MEMORANDUM REPORT NO. 201

**STUDY OF A LAKE PARKWAY (STH 794)
EXTENSION FROM EDGERTON AVENUE TO
STH 100 IN MILWAUKEE COUNTY**

Southeastern Wisconsin Regional Planning Commission

March 2012

Figure 2

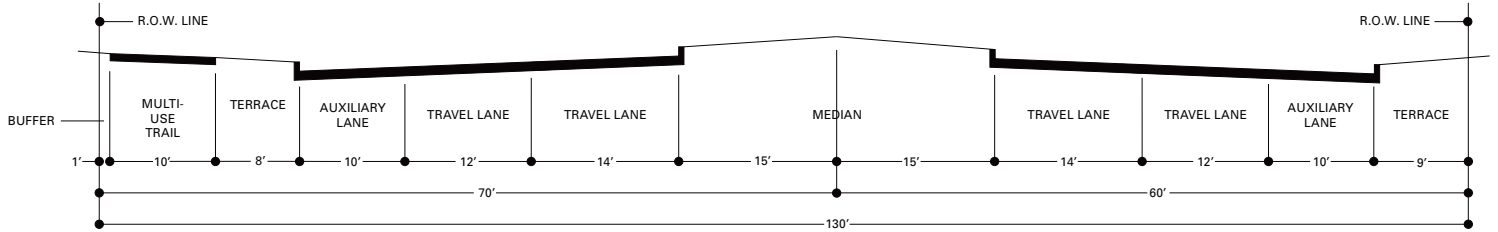
- Two persons questioned the need for a right-of-way width of 130 feet for a Lake Parkway extension.

Response: The cross-section for a Lake Parkway extension includes an approximate right-of-way width of 130 feet, which was used to determine potential right-of-way acquisitions and impacts of an extension. The cross-section is essentially the same as the existing typical cross-sections on the Lake Parkway between Edgerton and St. Francis Avenues, with the one difference being that an extension includes a multi-use trail to accommodate bicycles and pedestrians, while the existing Lake Parkway does not. It should be noted that it may be possible to reduce the right-of-way width by about 25 feet, particularly between roadway crossing treatments, by decreasing the median width by about 25 feet.

Map B-2
PREFERRED CROSSING TREATMENT FOR
LAKE PARKWAY EXTENSION AT COLLEGE AVENUE

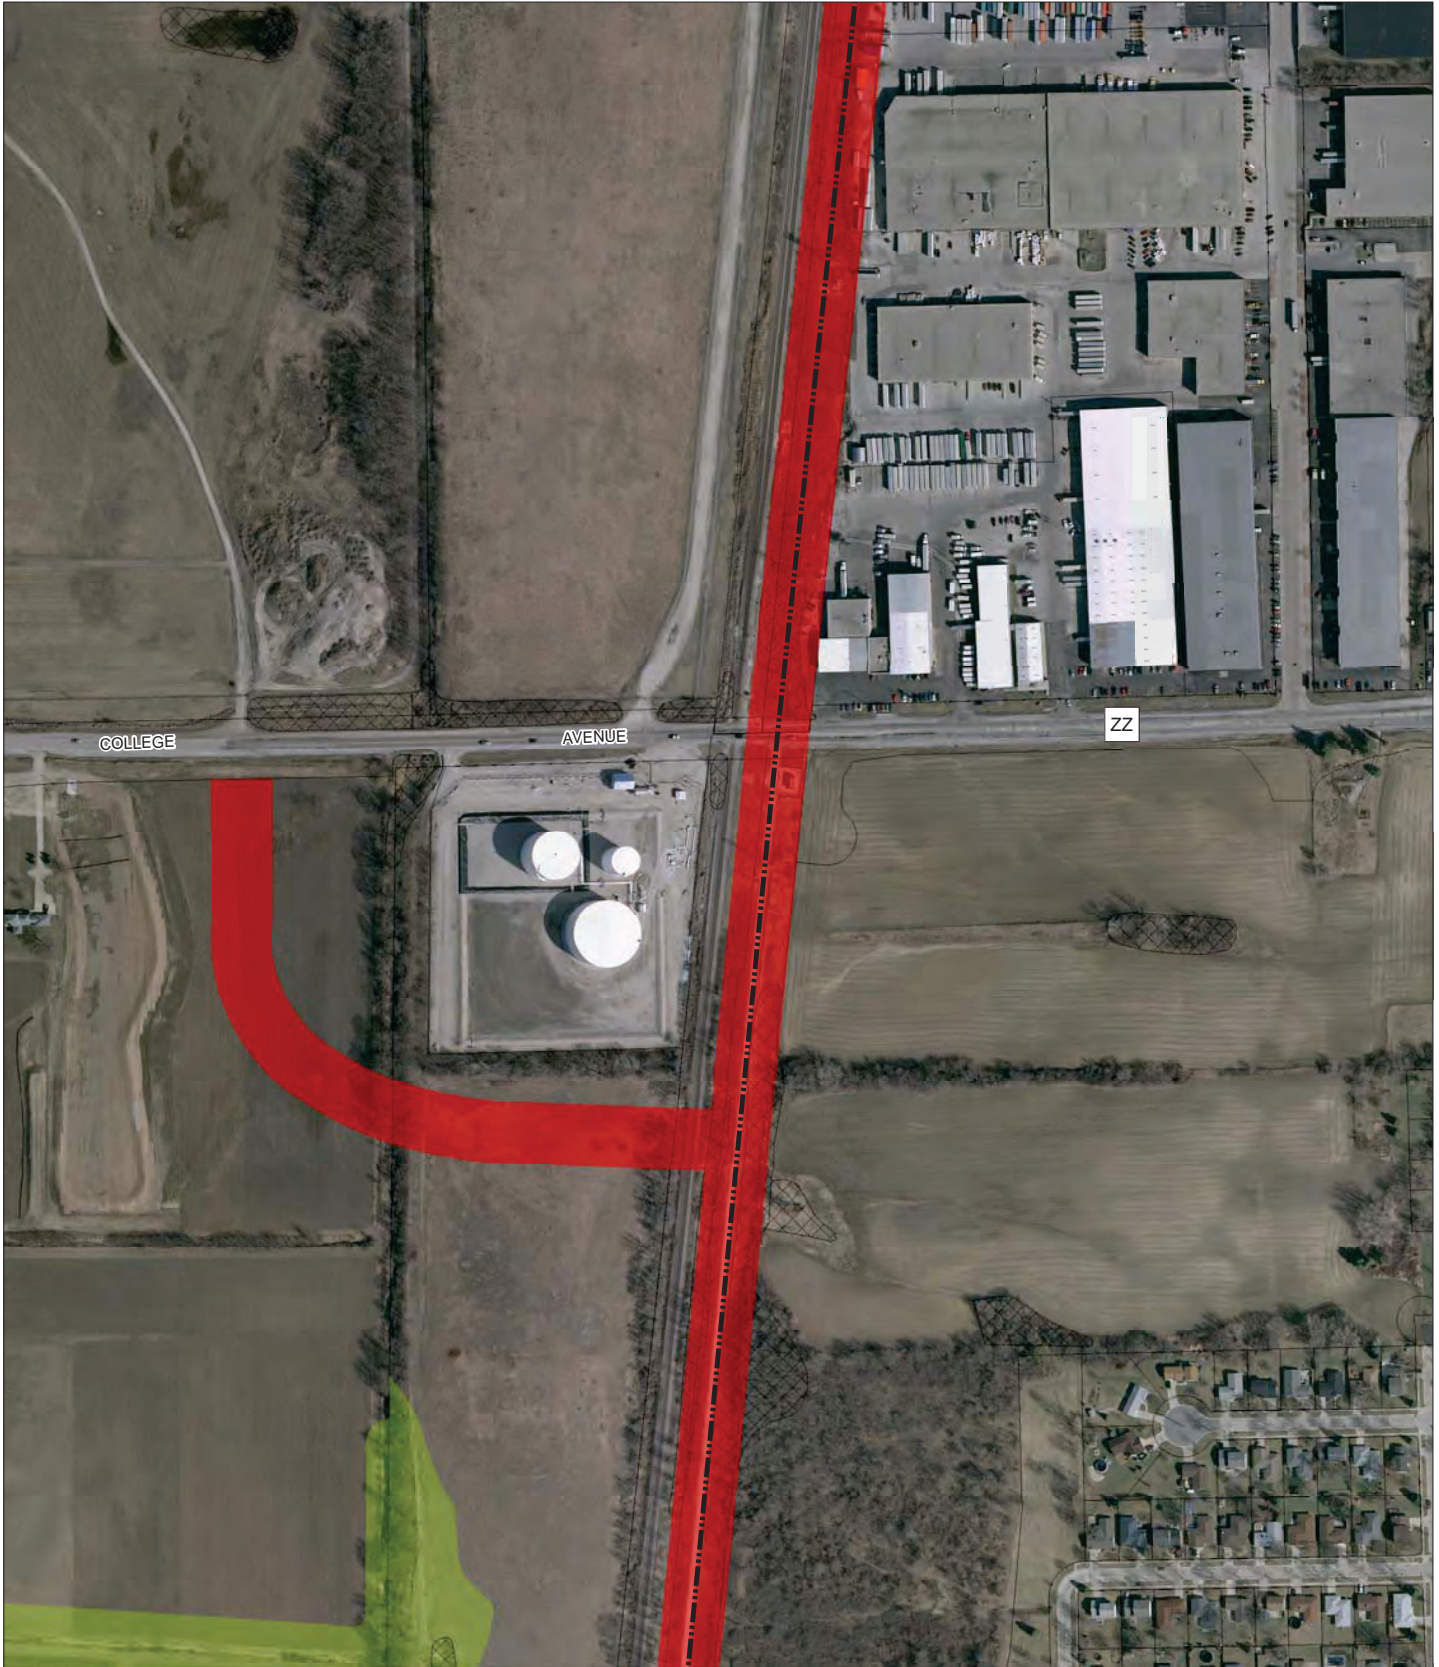
- Ten persons suggested changes to how and where to provide access to a Lake Parkway extension. Eight of the total ten persons suggested that a grade-separated interchange be considered at College Avenue—rather than an overpass with jughandle ramp access at College Avenue—which would result in all access to the extension being provided via grade-separated interchanges. One of the total ten persons suggested that a northbound off-ramp be constructed at Layton Avenue to create a full grade-separated interchange, rather than constructing northbound on- and off-ramps at Edgerton Avenue. One of the total ten persons suggested that the existing southbound Lake Parkway exit to Pennsylvania Avenue at Edgerton Avenue should be maintained—rather than removed to construct northbound on- and off-ramps at Edgerton Avenue. One of the total ten persons suggested that providing access at Drexel Avenue and Puetz Road would not be necessary. One of the total ten persons suggested that not providing access at Puetz Road—rather than a grade-separated interchange—would minimize the impact to primary environmental corridor and wetlands at that location. One of the total ten persons suggested that crossing roadways of the extension be constructed over—rather than under—the extension to eliminate the need for at-grade railroad crossings on those crossing roadways.

Response: Regardless of the specific roadway crossing treatments included in the study Advisory Committee's final recommendations, should the Advisory Committee continue to recommend a Lake Parkway extension, WisDOT would consider alternative crossing treatments at each roadway crossing for an extension during preliminary engineering and environmental impact studies, should an extension proceed to implementation.
